## STAFF REPORT Site Plan Review (Type III)

**SUBJECT:** **#187-ZON17-031 Site Plan Review for a new, two-story addition as a support structure to an existing ambulance service operation. The proposed addition will provide 9,400 square feet for office, light storage, and indoor parking garage uses.**

# BAY CITIES AMBULANCE PROPOSED MAINTENANCE GARAGE

**Attachment B**

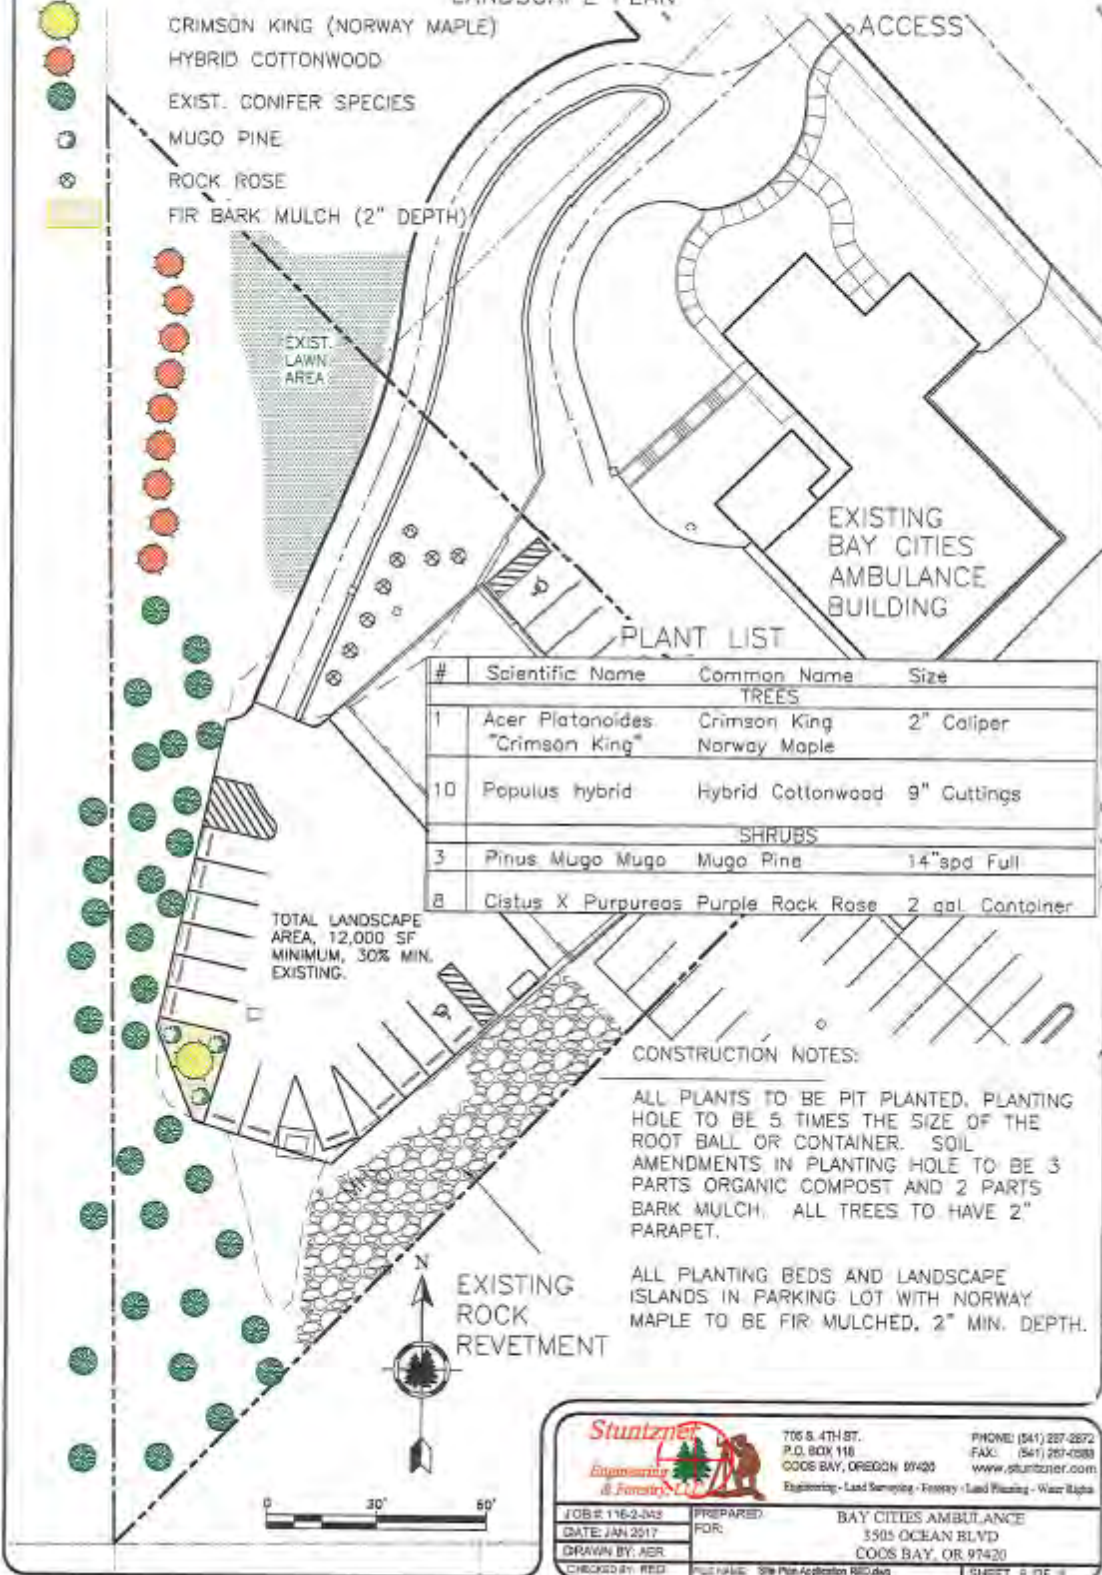
7. All landscaping must be maintained in a healthy, growth condition and landscaping material that become diseased and/or die shall be replaced within 30 days of the growth season.

## SITE PLAN APPLICATION PROPOSED IMPROVEMENTS PLAN

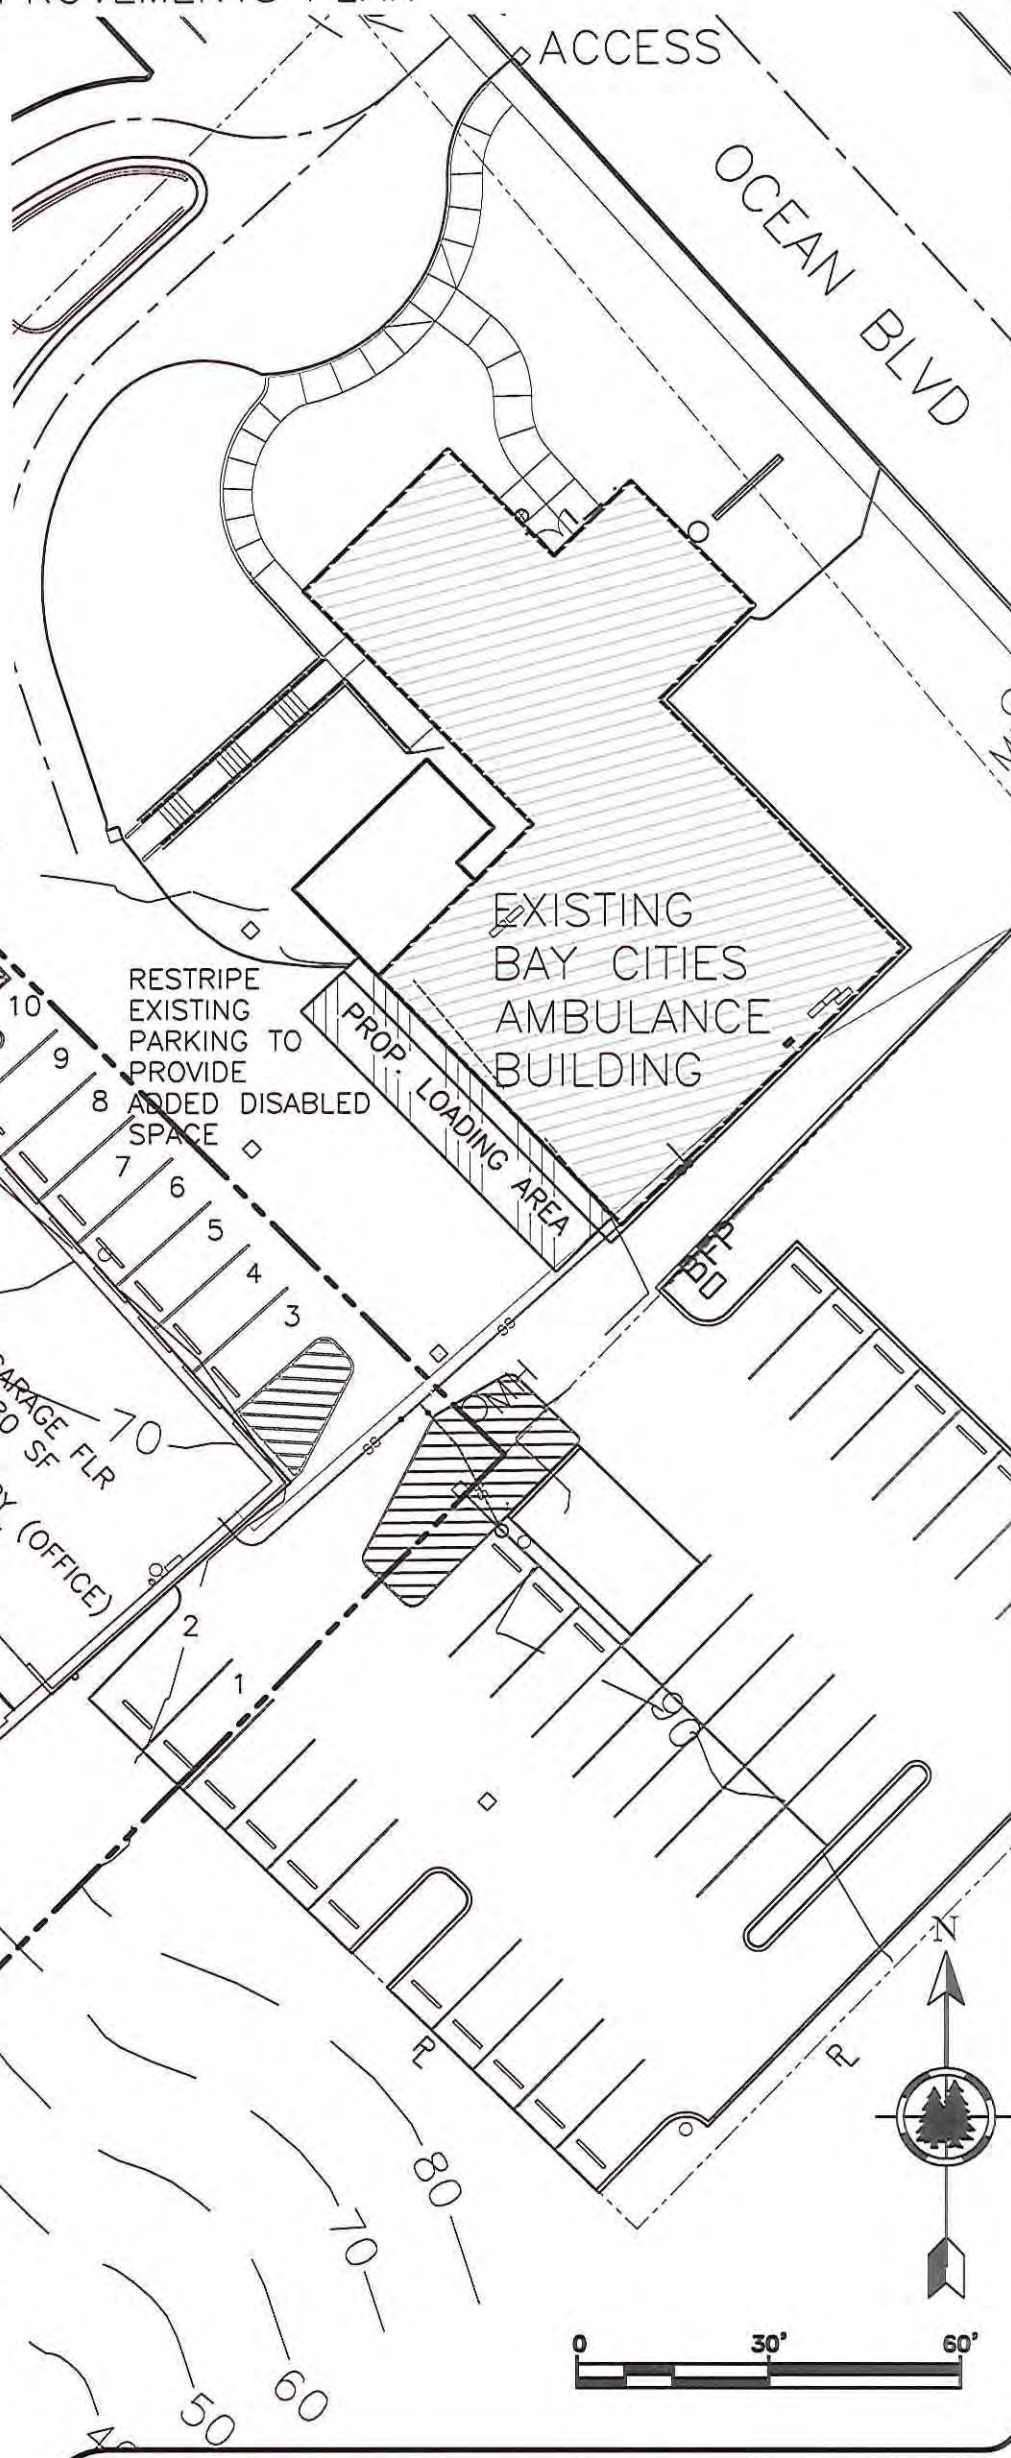
- 1) Access to proposed structure requires a 20-foot wide roadway.
- 2) Access roadway not to exceed 10% grade.
- 3) Access roadway to be built to withstand or support 60,000 lb. vehicles.
- 4) Proposed parking area required to allow fire truck turn around.
- 5) Is proposed structure to be equipped with Automatic Fire Sprinkler System?
- 6) 9,400-square foot structure requires 2,500 gallons per minute of fire flow.
- 7) Required fire flow needs to be within 225 feet of the structure.
- 8) Buildings in excess of 4,000 square feet are required to install a lock box.

3. The applicant shall satisfy all fire safety and fire response issues referenced under Approval Criterion #5 in the staff review.
4. The project development shall occur in substantial conformance with the submitted site plan dated January, 2017 except as amended to address fire and safety needs.

In order for this criterion to be satisfied, a condition of approval (#3) is necessary to ensure that the above issues are addressed.
